# Accessibility Survey

## City of Downey True Avenue - Telegraph Road to Cul-De-Sac

Date of Inspection  
6/19/2017

Prepared By  
**Disability Access Consultants**  
(800) 743-7067

**Change in Level South of Aliwin Street @ 33.949451032061, -118.098839074373**

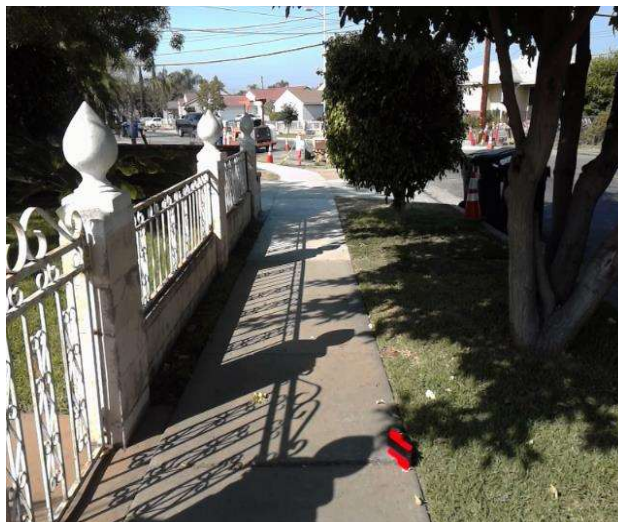
There is a change in elevation greater than recommended value.

**On-Site Finding** 0.75 inches

Ensure that the change in elevation is within the recommended value.

Recommendation Up to 0.25 inches

**Change in Level South of Cedartree Road @ 33.948617775053, -118.099005371332**

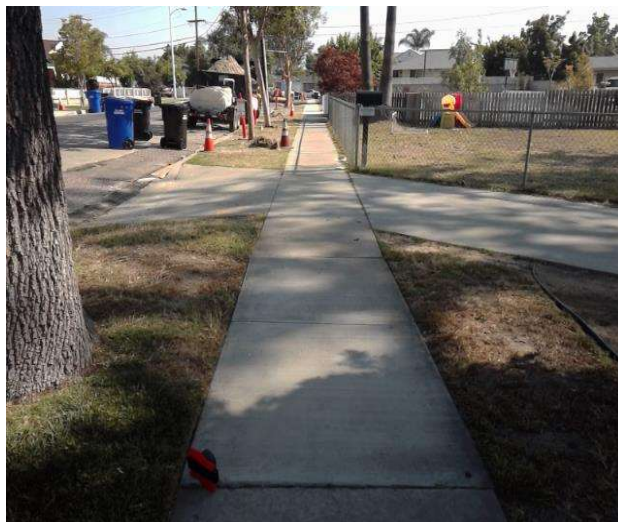
There is a change in elevation greater than recommended value.

**On-Site Finding** 0.62 inches

Ensure that the change in elevation is within the recommended value.

Recommendation Up to 0.25 inches

#### Change in Level North of Cul-De-Sac @ 33.947288329426, -118.100134581327

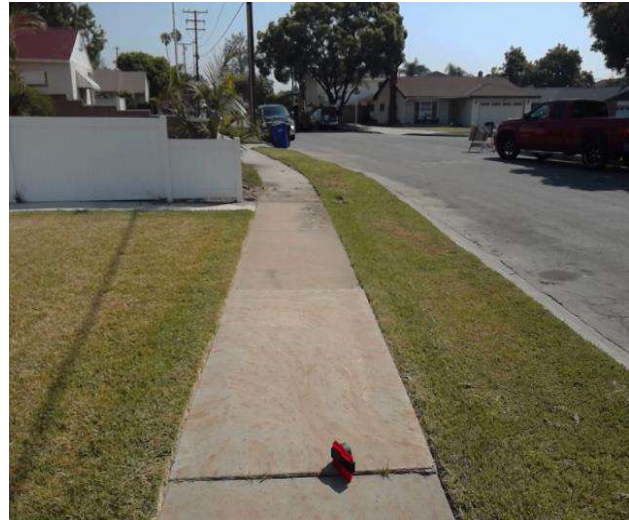
There is a change in elevation greater than recommended value.

**On-Site Finding** 0.50 inches

Ensure that the change in elevation is within the recommended value.

Recommendation Up to 0.25 inches

**Driveway South of Telegraph Road @ 33.951336677010, -118.096970915794**

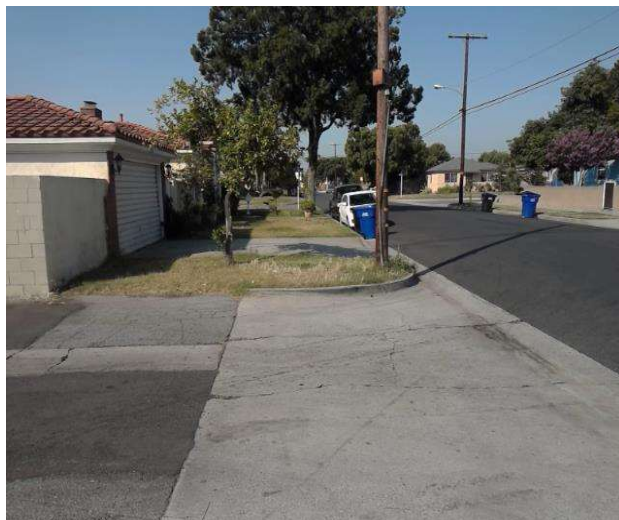
There are no detectable warnings where the pedestrian route crosses vehicular traffic.

**On-Site Finding** Not Found

Provide detectable warnings.

**Sidewalk South of Telegraph Road @ 33.951306640515, -118.097012490034**

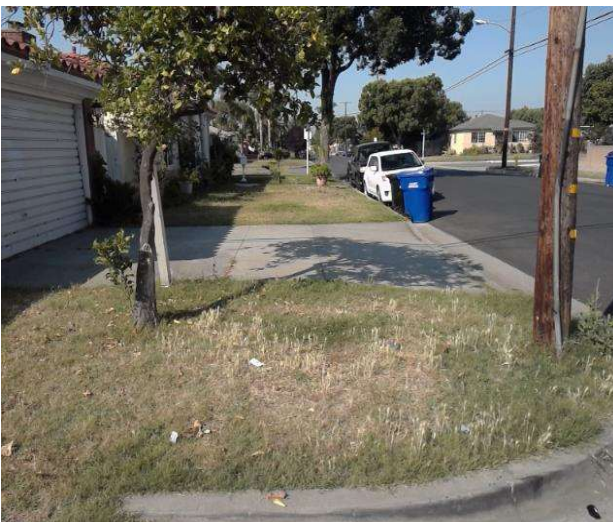
Section of sidewalk is missing and consists of dirt, grass or gravel.

**On-Site Finding** 108.00 feet

Provide a compliant sidewalk for the missing section.

**Sidewalk North of Cedartree Road @ 33.951363376107, -118.097178786993**

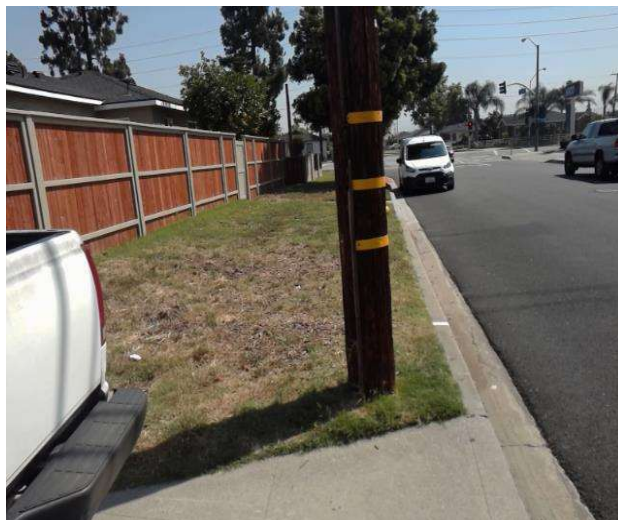
Section of sidewalk is missing and consists of dirt, grass or gravel.

**On-Site Finding** 107.00 feet

Provide a compliant sidewalk for the missing section.
